SERVICE BULLETIN

ENGINE — FAN SPEED/TRIM BALANCE PROBES ELECTRICAL HARNESS —
INTRODUCTION OF A NEW PART NUMBER

V2500 Series 72-0683

V2500-ENG-72-0683

ACCESS TO TERMINAL BLOCK OF NF HARNESS
FIGURE 3

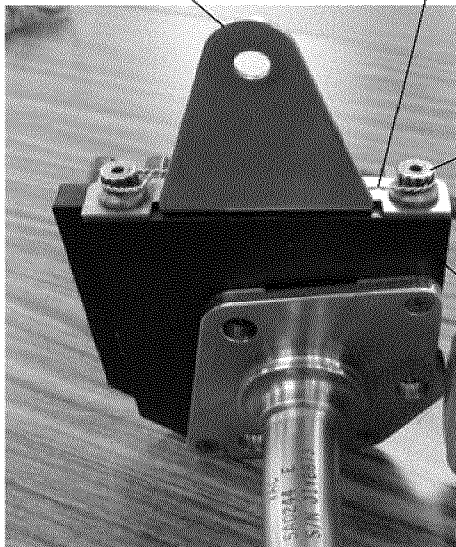
- (b) Remove and retain the bolt (71-52-43-01-316), the washer (71-52-43-01-319), the clip (71-52-43-01-321), the spacer (71-52-43-01-323) and the clip nut (71-52-43-01-325) from the clip position 5733. Refer to Figure 3. Reference 6, Engine Manual Chapter/Section 72-00-40-020-002, Removal-002.

LOCK WIRE
REPLACE AS SPECIFIED IN THE
ACCOMPLISHMENT INSTRUCTIONS

BOLTS
(72-32-37-01-460)
2 LOCATIONS
REMOVE AS SPECIFIED IN
THE ACCOMPLISHMENT
INSTRUCTIONS

LOCATION OF THE TERMINAL BLOCK PART NUMBER
FIGURE 4

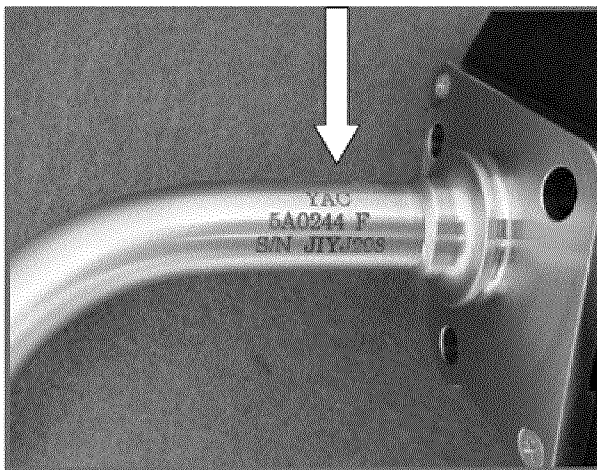
- (c) Remove and discard the lockwire.
 - (d) Remove and retain two bolts (72-32-37-01-460) and the bracket (72-32-37-01-450) from terminal block. Refer to Figure 4.

INSPECT FOR TERMINAL
BLOCK PART NUMBER
AS SPECIFIED IN THE
ACCOMPLISHMENT
INSTRUCTIONS

NOTE: The part number of terminal block is written on the contact surface with the bracket.

- (a) If the part number is "5A2198", only do the steps 1.A.(3) and 1.A.(4).
 - (b) If the part number is not "5A2198", only do the steps 1.A.(5), 1.A.(6) and 1.A.(7) to replace the NF harness.

LOCATION OF THE NF HARNESS PART NUMBER
FIGURE 5

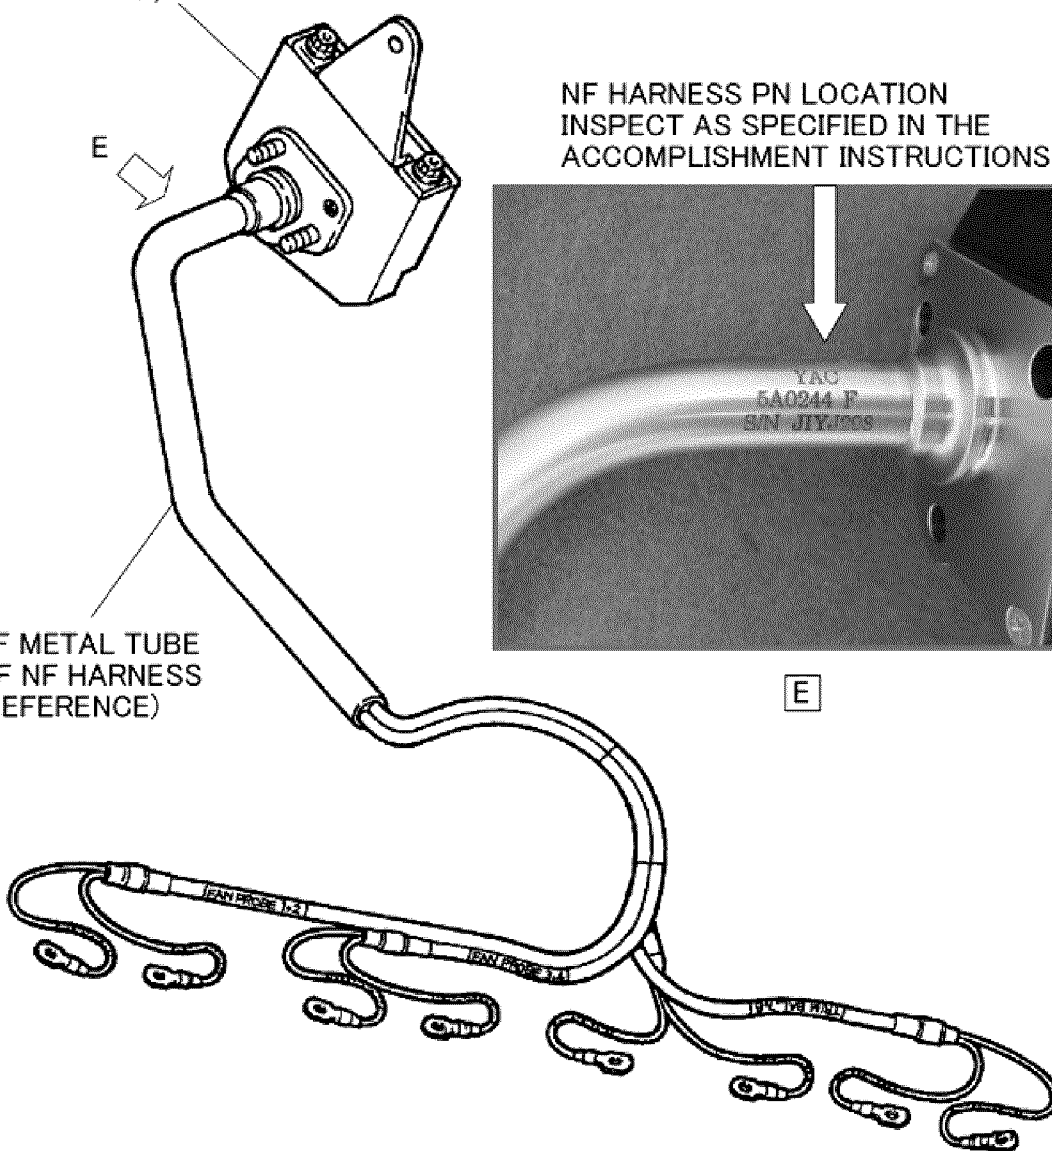
NF HARNESS PN LOCATION
INSPECT AS SPECIFIED IN THE
ACCOMPLISHMENT INSTRUCTIONS

NOTE: The part number and change letter of NF harness is written on the metal tube.

- (1) If the part number and change letter is "5A0244" and revision "F", only do steps 2.B and 2.C to reidentify the part number.
 - (2) If the part number and change letter is "5A0244" prior to revision "F", only do step 2.D to replace the NF harness

NF HARNESS
FIGURE 6

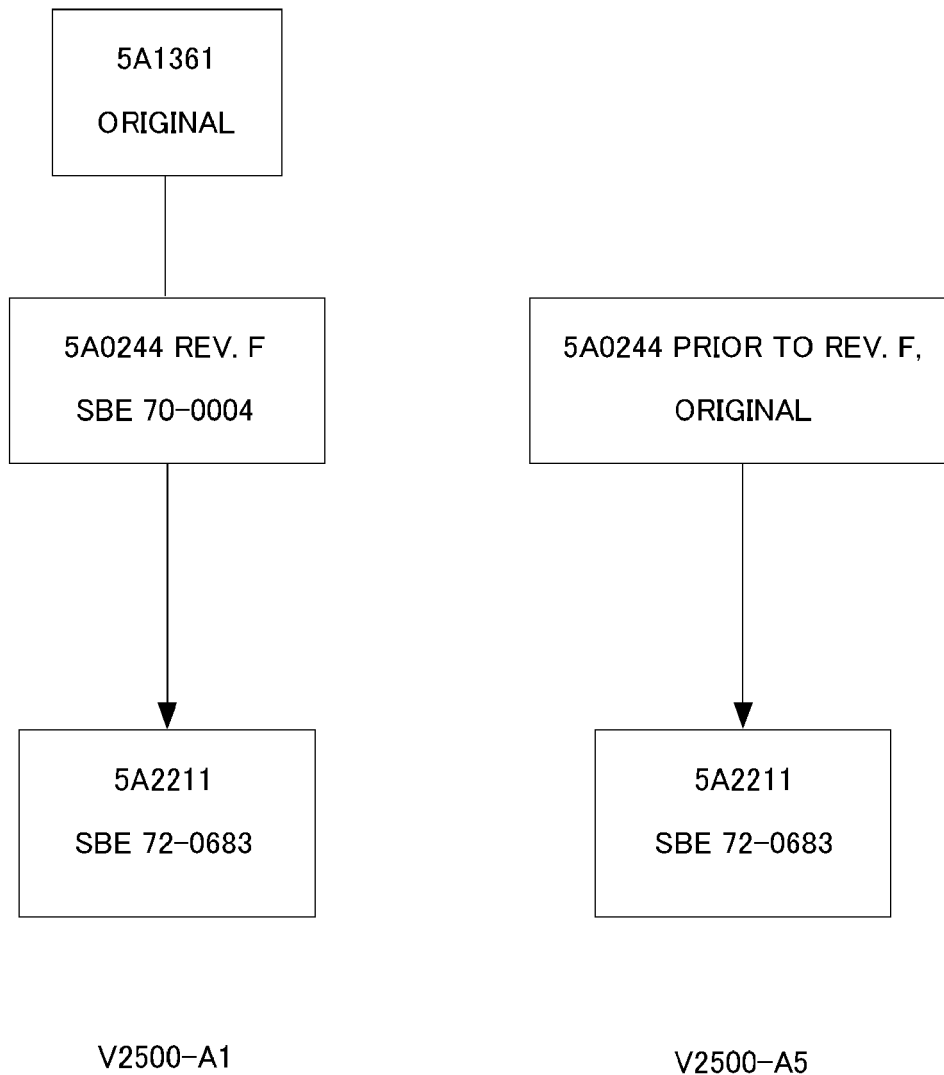
1. Condition: NF harness leads electrical signal from the NF probe on the front bearing chamber to the fan frame aft side. This Service Bulletin introduces a new part number 5A2211 instead of the current PN 5A0244. NF Harness PN 5A2211 is identical and re-numbered from NF Harness PN 5A0244 Rev.F.

See Figure 6.
